Crystal View Neighborhood

RE: Concerns Regarding Proposed Pinnacle at Liberty Bay PRD Adjacent to Crystal View - Request for Compliance with PMC 18.260.070 (A) and (B).

From: [Tracie hannah](#)
To: [Tiffany Simmons](#); [Tracie hannah](#)
Subject: Request for Clarification on Pinnacle at Liberty Bay PRD Compliance with RL Zoning Standards
Date: Monday, August 25, 2025 9:11:59 AM
Attachments: [image.png](#)
[image.png](#)
[image.png](#)

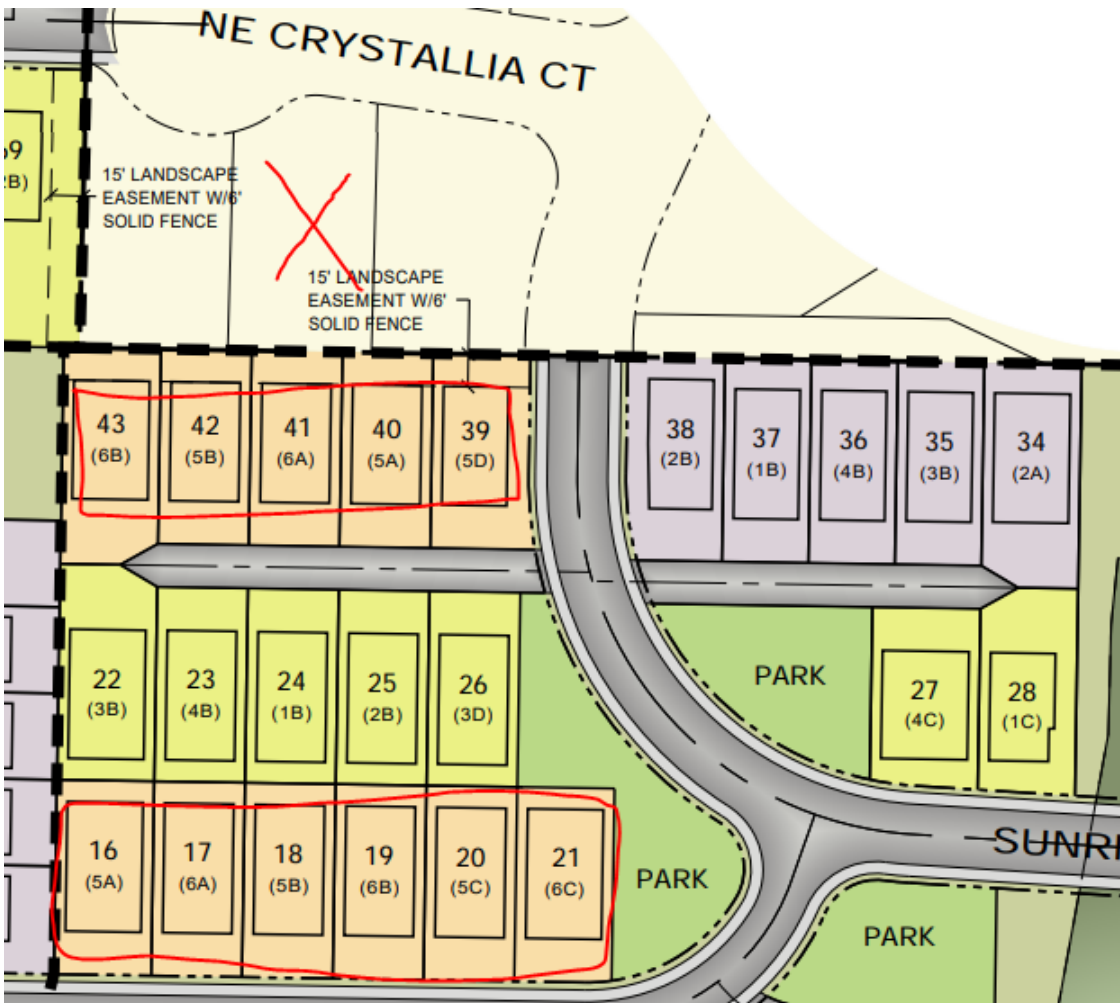
The proposal indicates three-story homes ranging from 37 to 39 feet in height — and these taller homes appear to be placed only in the row directly in front of our Crystal View neighborhood, which would block existing water views and diminish property values by an estimated \$50,000 or more per home. This raises the question of why homes exceeding the 35-foot maximum are being considered at all, and why they are concentrated specifically where they will have the greatest negative impact on existing homeowners.

3. How are the lot width (50 ft.), lot depth (80 ft.), and maximum building height (35 ft.) requirements being applied in the proposed site plan?
4. On what basis would homes taller than 35 feet (up to 39 feet) be permitted, when the RL zone code prohibits structures exceeding 35 feet?
